Illawarra Coal

**Response to Submissions
Appin Vent Shaft No 6 Project (00-0079)**

Illawarra Coal response to Submissions

Figure 1 Site Location

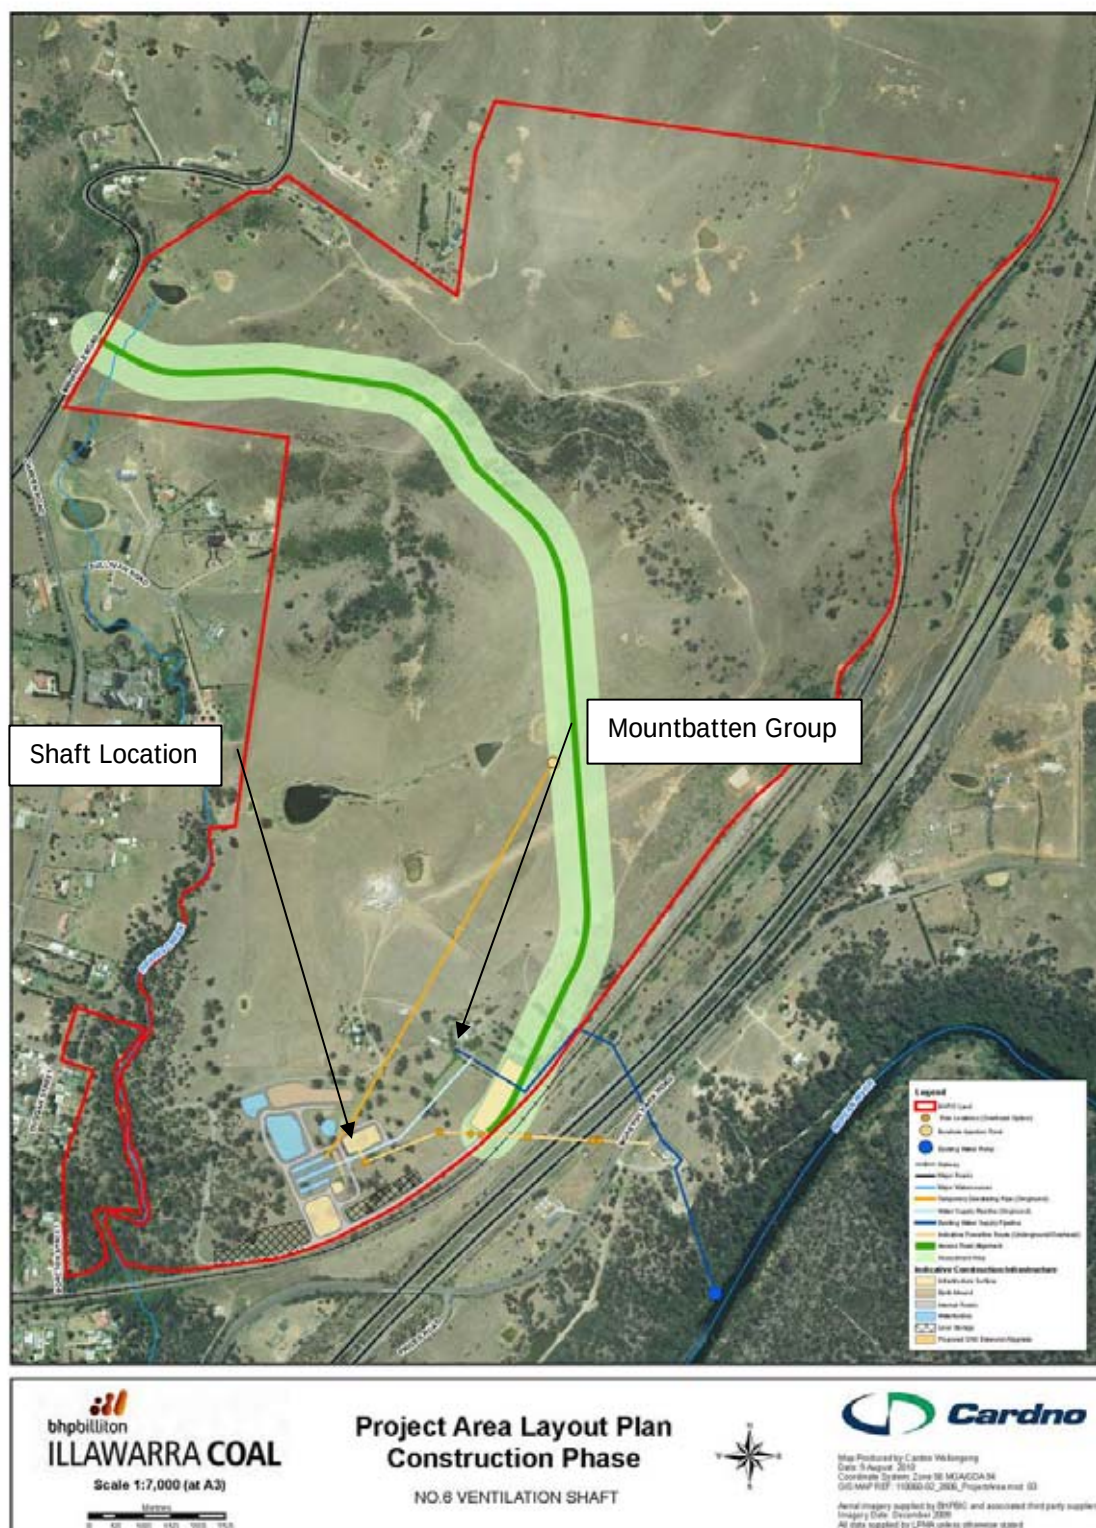
Wilkinson Murray Report 10112 was a noise assessment of the proposed Vent Shaft #6 at Douglas Park, NSW. In response to the environmental assessment of the project, the Heritage Branch of the NSW Department of Planning have requested further information concerning the potential impacts of the proposal on heritage items near the proposal. In particular, they request further assessment at the Mountbatten Group of heritage buildings. This group of buildings is approximately 350m from the site of the proposed vent shaft.

Figure 1 also shows the location of the Mountbatten Group of buildings with respect to the site. The proposed access road (shown in green on the figure) would pass approximately 100m to the east of the Mountbatten Group. Due to the distance to the buildings from the site, risk of damage from noise and vibration is considered low. However, in this report the following potential risks are assessed:

No impact from noise and vibration is predicted at the buildings as they are sufficiently distant from the site, and the access road, to allow all noise and vibration to fall to levels well below relevant criteria.
